In support of comments #63, #64, #65, #66, and #67

IEEE P802.3cp Task Force, Teleconference, 23 September 2020

Figure 140–2a—OMA_{outer} (max) and OMA_{outer} (min) versus TDECQ for 100GBASE-FR1 and 100GBASE-LR1

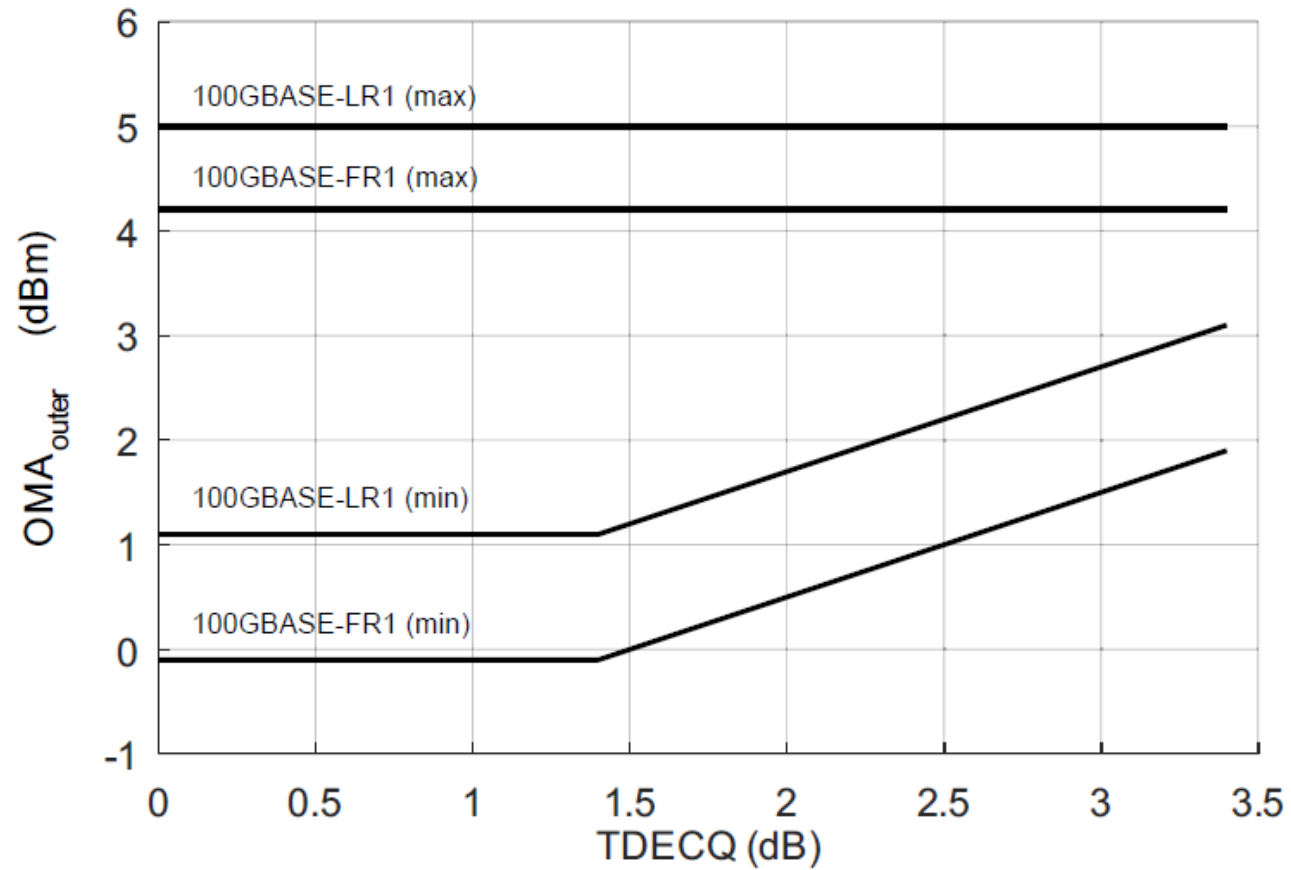
- The further changes in P802.3cu D3.0 are purely how certain parameters are represented and additionally removing dependency on extinction ratio
- Launch power in “ $\text{OMA}_{\text{outer}}$ minus TDECQ”, with a fixed limit, is rewritten as “ $\text{OMA}_{\text{outer}}$ ” as “value + TDECQ”.

- With this new representation, it is more clear that below TDECQ the minimum output power is flat, whereas for above TDECQ it goes up linearly with TDECQ. Furthermore simplification without ER.
- Additionally a clarifying Figure has been added (see following page)
- It is proposed to add such a clarifying figure.

Figure 140-2b—Receiver sensitivity (OMA_{outer}) (max) for 100GBASE-FR1 and 100GBASE-LR1

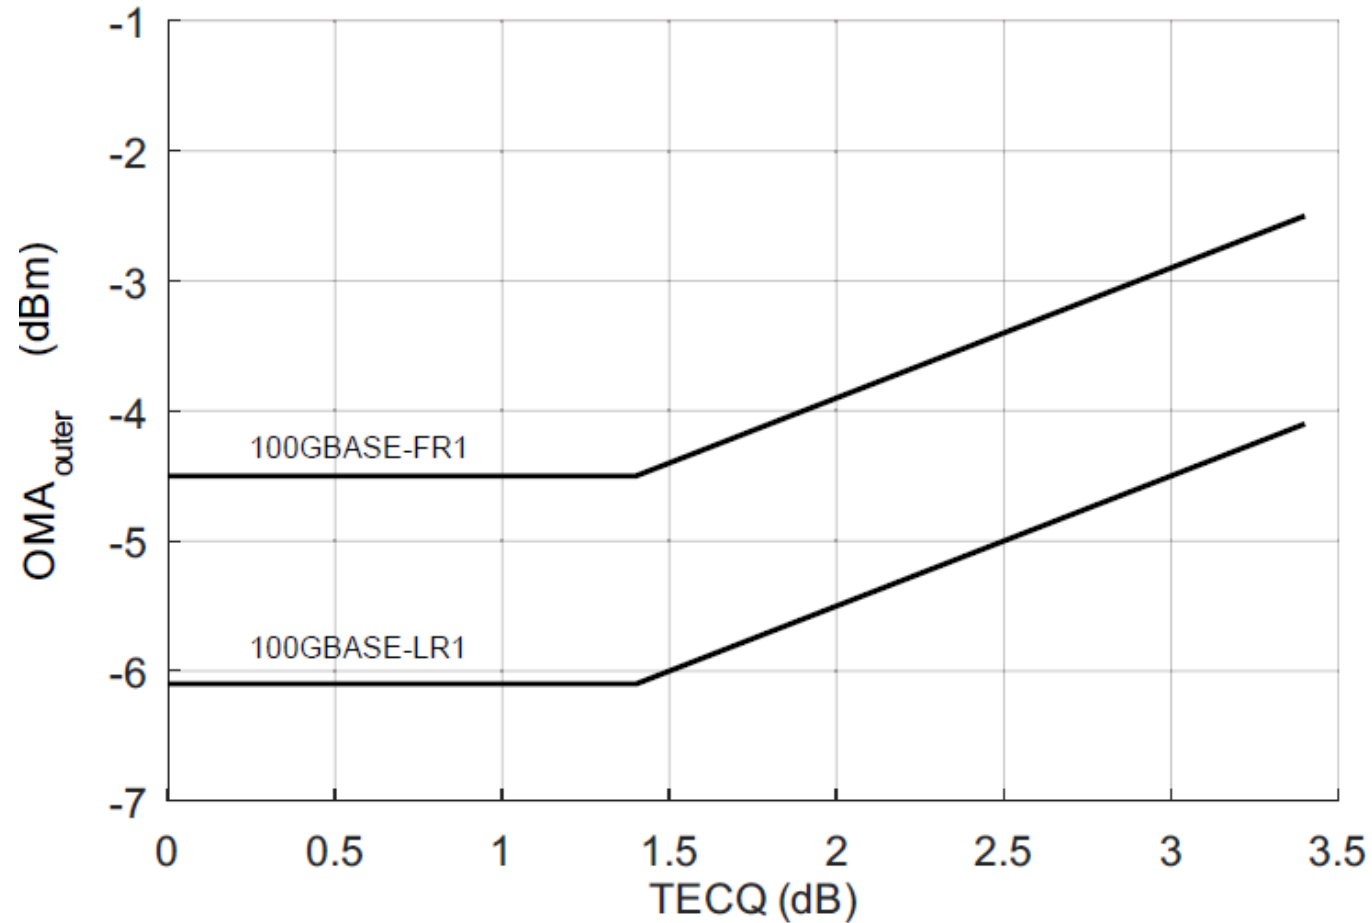
- In a similar way, the receiver sensitivity has been expressed differently.

- Instead of referring to Equations, values are shown in relation to TECQ.
- With this new representation, it is more clear that below TECQ the requirement for Rx sensitivity is flat, whereas for above TECQ it goes up linearly with TECQ.
- Additionally a clarifying Figure has been added (see following page)
- It is proposed to add such a clarifying figure.
